# Office Action Summary

10/695,586

BARTIMUS, CHRISTOPHER  
SHAWN

**DETAILED ACTION**

Fig. 1

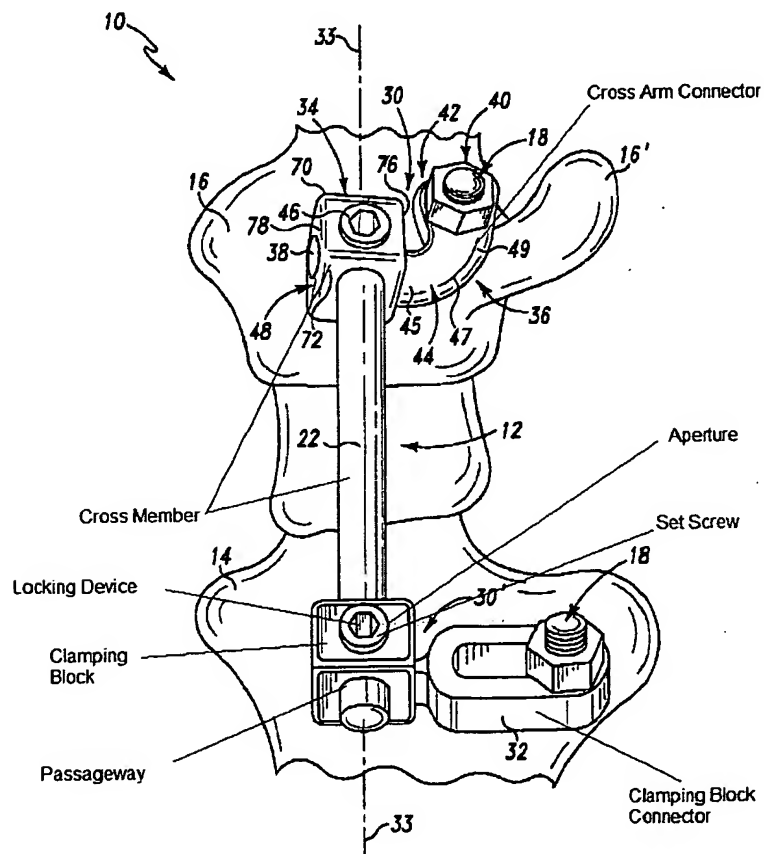
Krag discloses a multi-axial fixation device for use in aligning spinal members during operation, the device comprising: a clamping block (Fig. 1 below) the clamping block defining a passageway (Fig. 1 below), the passageway configured to receive a cross member therein, the clamping block having a clamping block connector (Fig. 1 below) connected thereto, and the clamping block connector is capable of connection with a first spinal member.

The cross member is capable of insertion within the passageway (Fig. 1 below), the cross member having a cross arm connector (Fig. 1 below) connected thereto, the cross arm connector configured to connect with a second spinal member, the cross member configured for variable locked positioning within the clamping block by a locking device (Fig. 1 below); the locking device is capable of allowing the cross member to be variously adjustably positioned and held within the clamping block; the clamping block, the locking device and the

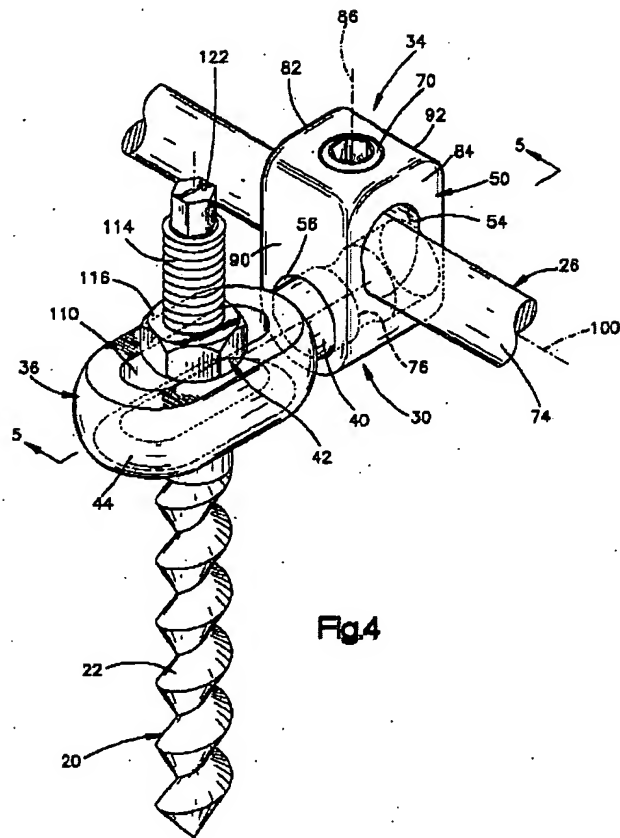
(as seen in Fig. 4 below, ref. 56 from US Pat. 5,741,255, incorporated by reference in column 2, lines 41-43). The device further comprises a retaining clip, the retaining clip configured to allow the locking device to be retained and removed from within the clamping block. The retaining clip can be considered to be the thread of the set screw (Fig. 1 below). The cross member passes through the passageway (Fig. 1) and the locking device is capable of allowing variable linear, rotational, and angular positioning of the cross member. The angles and location of the cross member connector and the clamping block connector are capable of being used in series and combination for use in multiple level fusions and bridging. The locking device is capable of postoperative access by a non-invasive means to accomplish a variety of postoperative adjustments. The device is capable of allowing selective disengagement and adjustment of the spinal members in one direction while retaining the spinal members in a secured position in a second direction.

since it can rotate and slide in its respective aperture (Fig. 4 above from US Pat. 5,741,255, incorporated by reference in column 2, lines 41-43); the clamping block, the locking device and the cross member are configured to allow variable positioning and locking of the cross member thereby allowing multiple adjustable positioning of the spinal members, since the cross member can slide in the clamping block when not in a locked position (Fig. 4 above from US Pat. 5,741,255, incorporated by reference in column 2, lines 41-43); affixing pedicle screws or anchoring device as presently used in the field to each side of the disk space to be bridged (Fig. 1 above), attaching the embodied mechanism on the threaded pedicle screws with nuts (Fig. 1 above); aligning the spine across the affected disk space to be anatomically correct (column 2, lines 15-16) and tightening the set screw (column 3, lines 14-19); and making adjustments postoperatively by a non-invasive procedure if necessary (column 6, lines 8-11).

Fig. 7

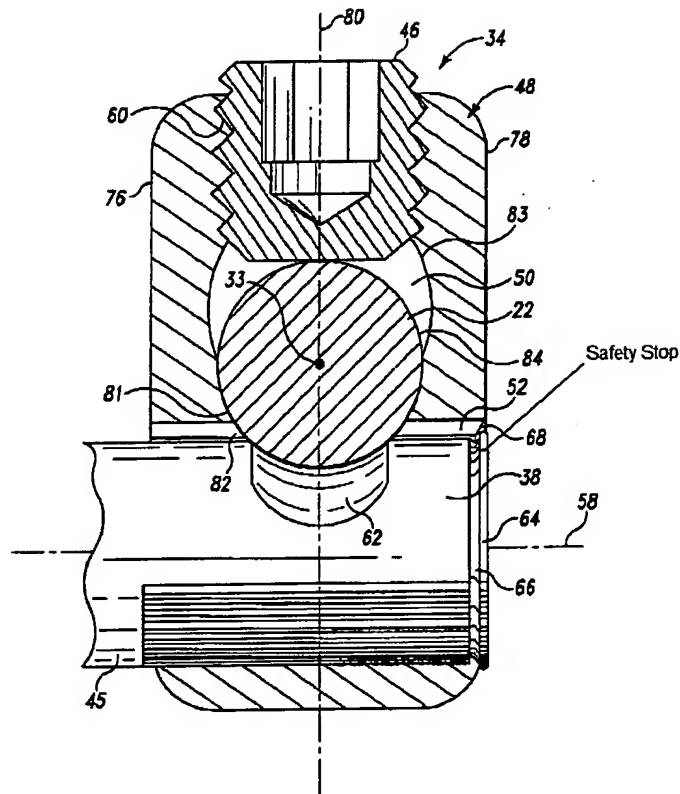
cross member are capable of allowing variable positioning and locking of the cross member thereby allowing multiple adjustable positioning of the spinal members. The locking device comprises a plurality of stacked portions (the portions of the cross member, the set screw, and the clamping block involved in locking the device, Fig. 1) that are configured to lock and hold the cross member by compressive force upon the stacked portions. The passageway is a transverse multi-positional opening through the clamping block. The passageway extends through the clamping block and the cross member can be swiveled in the passageway and can be locked in a variety of positions, hence the passageway is a transverse, multi-positional opening through the clamping block. A cross arm connector and the clamping block connector are each capable of connecting with a spinal member through the use of a pedicle screw (Fig. 1). The cross member connector further comprises a safety stop (Fig. 7 below); the safety stop is capable of preventing withdrawal of the cross member from the passageway. The locking device is multiply adjustable through the use of a set screw (Fig. 1 below). The clamping block further defines an aperture (Fig. 1 below) configured to maintain and hold the set screw within the clamping block. The clamping block is configured to have a flat surface with rounded edges (Fig. 2) and is capable of preventing discomfort that may be experienced by the recipient. The clamping block is configured to define at least one access opening, the access opening capable of allowing the passage of body fluids around the clamping block. The access opening can be considered to be the aperture through which the clamping block connector is connected to the clamping block

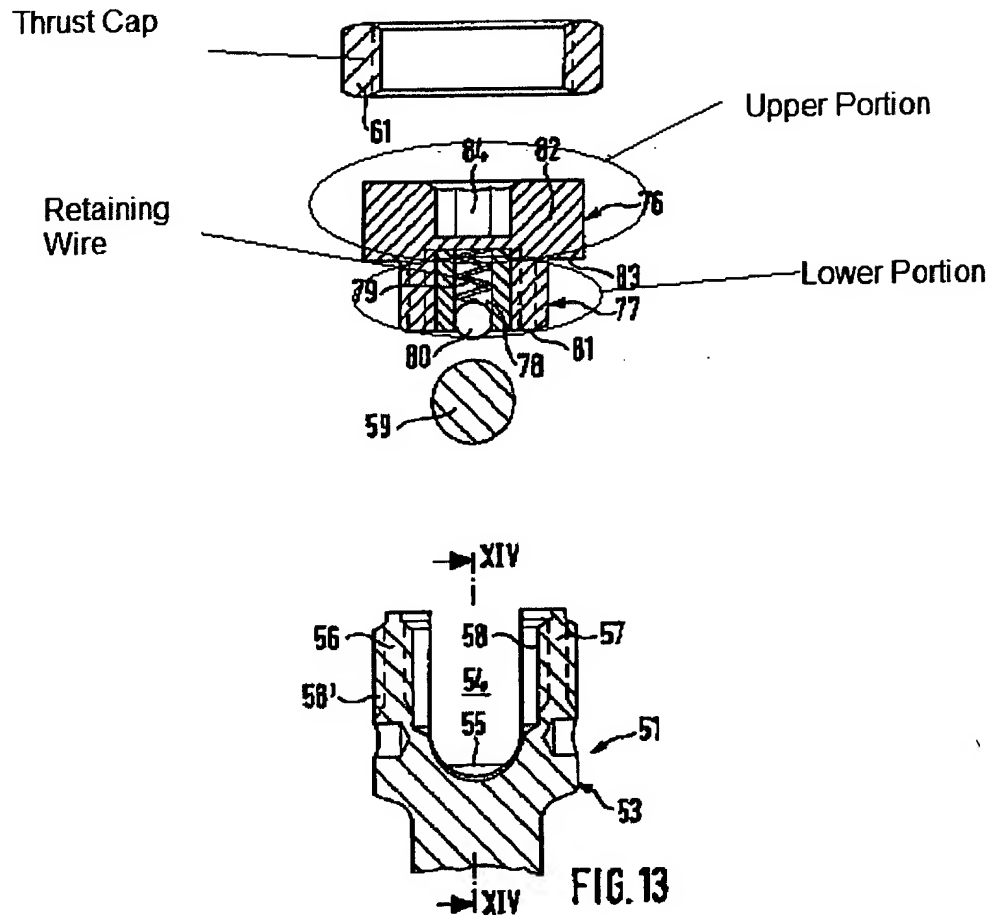
Biederman et al. disclose: a thrust cap (Fig. 13 below), an upper portion (Fig. 13 below) and a lower portion (Fig. 13 below), the thrust cap the upper portion and the lower portion each having a radius configured to interact with an adjoining portion when placed in a desired position and orientation, the upper portion and the lower portion each having a radius center and configured so that the radius centers are offset when the upper portion and the lower portion are placed in correct alignment within the clamping block. The thrust cap is held in position by a retaining wire (Fig. 13 below) configured to retain the thrust cap from sliding out of the clamping block and preventing the whole system from disassembling when in a loosened state. The thrust cap, upper portion and lower portions are used in order to obtain a rigid connection between the anchoring member and the rod and also to allow an easy manipulation for precisely

It would have been obvious to a person having ordinary skill in the art at the time the invention was made to have constructed the locking mechanism of Krag with the thrust cap, upper portion, lower portion, and retaining wire of Biedermann et al. This would help to create a more rigid connection between the cross member of Krag and the clamping block of Krag, and furthermore would allow an easy manipulation for precisely adjusting the position between the cross member of Krag and the clamping block of Krag before finally locking the position of the multi-axial fixation device (Biederman, abstract, lines 11-17).
